Access Compliance Report

Public Rights-of-Way

Intersection ID: 11815	Main Street: N_POPLAR_ST	Cross Street: W_7TH_ST	Location: E
ADA ID: 2ADE4DF72ADB	Ramp Type: PerpDiag	Initial Pass/Fail: Fail	Overall Compliance: No
		Severity Score: 22.5

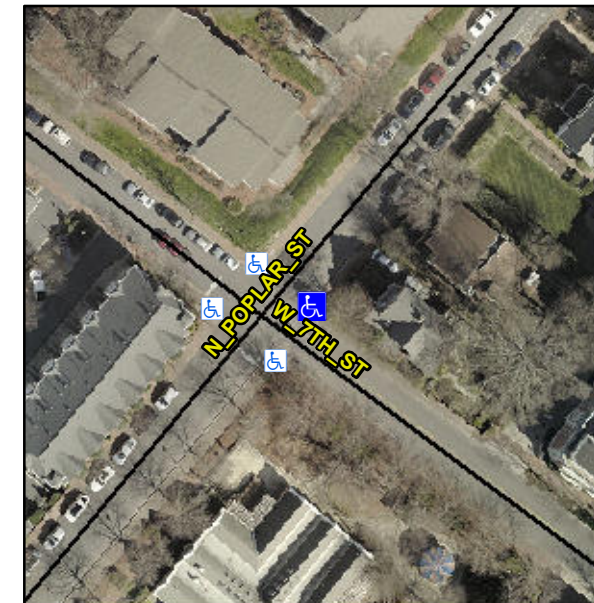
Not Found, R304.5.1, R304.2.2, R304.5.3

Compliance	Description	Data	Compliance	Description	Data
N/A	Ramp Length (in)	49.0	No	Ramp Slope (%)	9.6
No	Ramp Width (in)	38.0	No	Ramp XSlope (%)	2.9
N/A	Flare Type LT	N/A	N/A	Flare Type RT	N/A
N/A	Flare Slope LT (%)	N/A	N/A	Flare Slope RT (%)	N/A
N/A	Flare Traversable LT?	N/A	N/A	Flare Traversable RT?	N/A
N/A	Landing Length (in)	N/A	N/A	DWS Provided?	N/A
N/A	Landing Width (in)	N/A	N/A	DWS Contrast?	N/A
N/A	Landing Slope (%)	N/A	N/A	DWS Length (in)	N/A
N/A	Landing X Slope (%)	N/A	N/A	DWS Full Width?	N/A
N/A	Landing Curb? (Y/N)	N/A	N/A	DWS Offset (in)	N/A
N/A	Shared Landing?	N/A			
N/A	Gutter Ponding?	N/A	N/A	Gutter Slope (%)	N/A
N/A	Gutter Lip Ht (in)	N/A	N/A	Gutter X Slope (%)	N/A
N/A	Painted X Walk1?	No	N/A	Painted X Walk2?	No
	X Walk 1 Direction	To NW		X Walk 2 Direction	To SW
N/A	X Walk 1 Width (in)	N/A	N/A	X Walk 2 Width (in)	N/A
	X Walk 1 Slope (%)	4.2		X Walk 2 Slope (%)	3.5
	X Walk 1 X Slope (%)	2.9		X Walk 2 X Slope (%)	0.9

Remove & Replace Curb Ramp With Two New Directional Ramps or Equivalent.
